s72 Amendment Planning Assessment - Officer Report

PA1900742-2 – 572-574 Lonsdale Street, 248-250 And 256-260 King Street and Gough Alley (Corporation Lane 17), Melbourne

Section 72 Amendment Planning Assessment - Officer Report Development Assessment

Figure 1: Approved (left) and proposed (right) schemes (Source: Application)

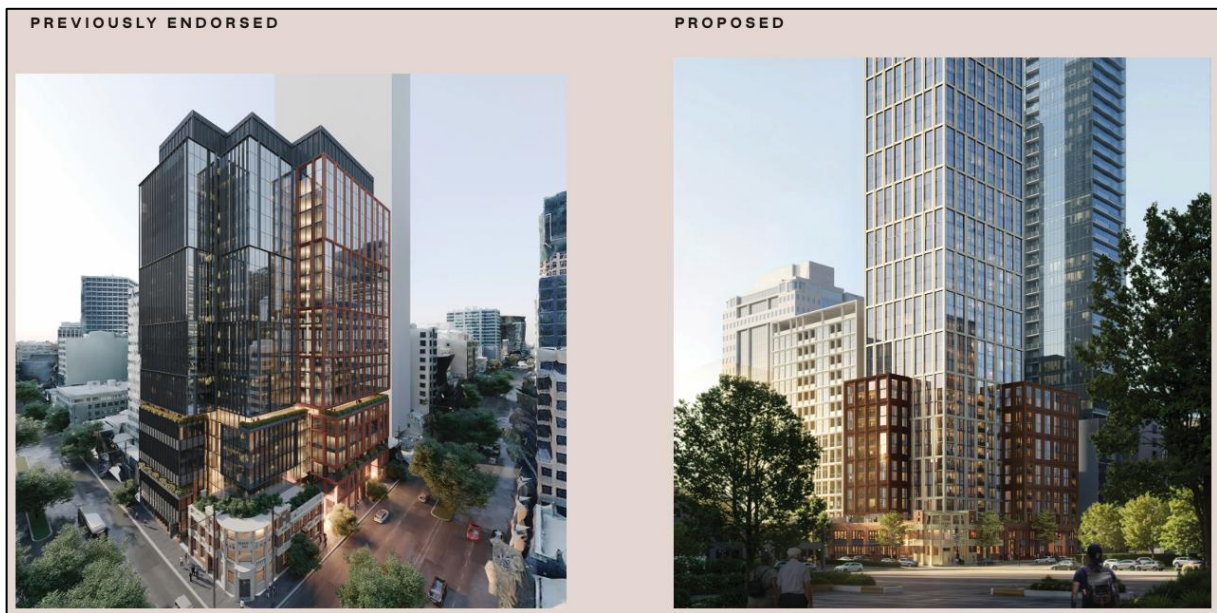
3. The proposal seeks a section 72 amendment to the permit and plans to change the land use from office to dwellings, with associated built form and design changes and associated changes to conditions to reflect the new scheme.

4. The proposal seeks the construction of a 48 storey residential building, plus three levels of basement and rooftop plant.
5. There is no additional demolition of buildings, as previously approved under the existing permit. Significant fabric of the former Kilkenny Inn building will continue to be retained.

8. The tower form has been redesigned to reflect the new dwelling uses.
9. Materials and finishes have also been altered.

Figure 2: Approved (left) and proposed (right) ground floor plan (Source: Application)

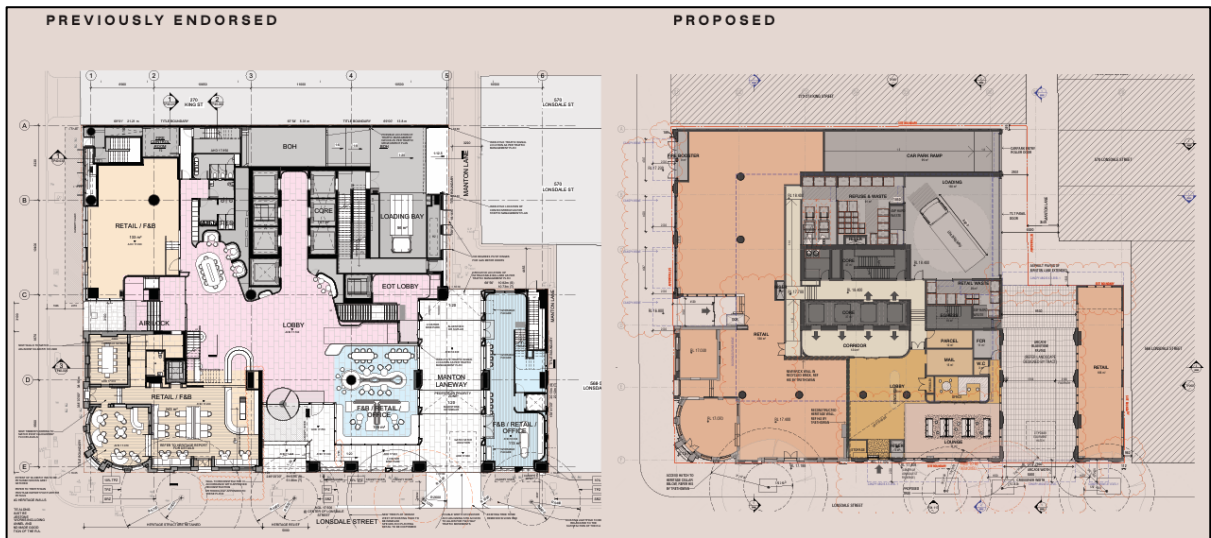
- *The Ground Floor remains high quality.*
 - *The proposal continues to provide several retail tenancies, a legible lobby/lounge area, a through-block arcade and consolidated carparking/loading to Manton Lane.*

Figure 6: Massing response (street wall heights)

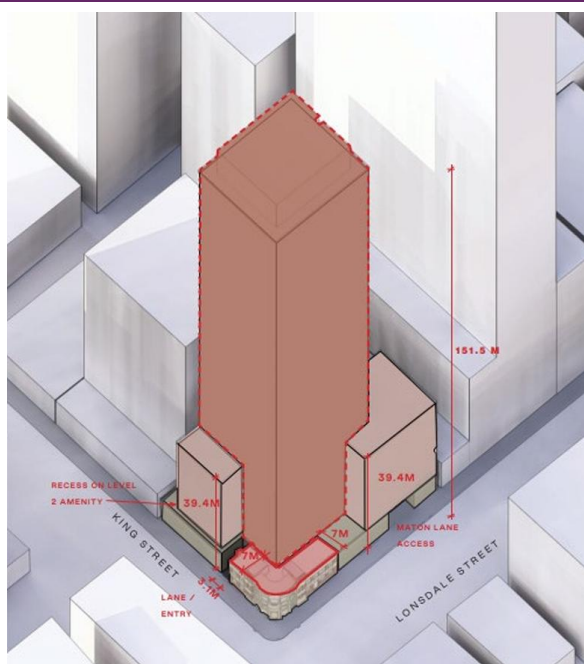
The proposed street wall height along Lonsdale Street and King Street measures 39.39 metres (measured from the centre of the Lonsdale Street frontage of 17.41 metres AHD). Above this street wall, is an architectural feature with the façade extending a further 3 metres in height to enclose the Level 12 terraces. While this exceeds the preferred

requirement of 20 metres, it is within the modified requirement of 40 metres.

Proposal complies with the modified requirement.

Figure 7: Preferred DDO10 setback requirements (Left) and proposed setbacks (Right) (Source: Application)

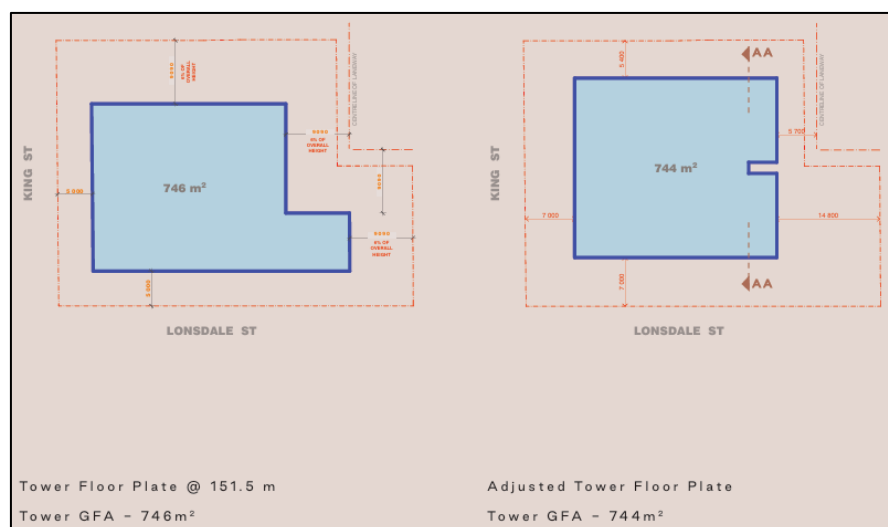
The proposed building has a setback to the side boundaries above the street wall of 5.4 metres to the northern boundary and between 5.7 metres (to the centre of Manton Lane) and 14.8 metres to the eastern boundary. These setbacks comply with the mandatory modified minimum 5 metre setback requirements.

Similar to the street wall setback requirement discussed above, the built form outcomes for side setbacks are considered to be met due to the varied setbacks provided around the tower. The irregular setbacks ensure that sun penetration to the street is adequately maintained throughout the day and provides for reasonable and equitable access to daylight, privacy and outlook having regard to adjoining properties. The setbacks will provide clear open sky views and articulation ensuring that the building does not present as a continuous wall at street level.

Importantly, the setbacks of the tower from the Kilkeny Inn building provides a respectful separation and transition and ensures that it will not adversely affect the heritage place.

Proposal complies with the modified requirement.

Figure 9: Entry points and activation at ground plane

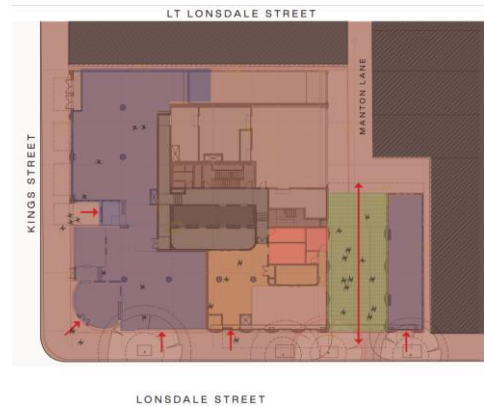
The proposal is appropriately designed to address the public realm, providing a high level of activation to the street and internal connections.

Direct entry points are provided to the retail tenancies from King Street and Lonsdale Street and the Manton Lane extension.
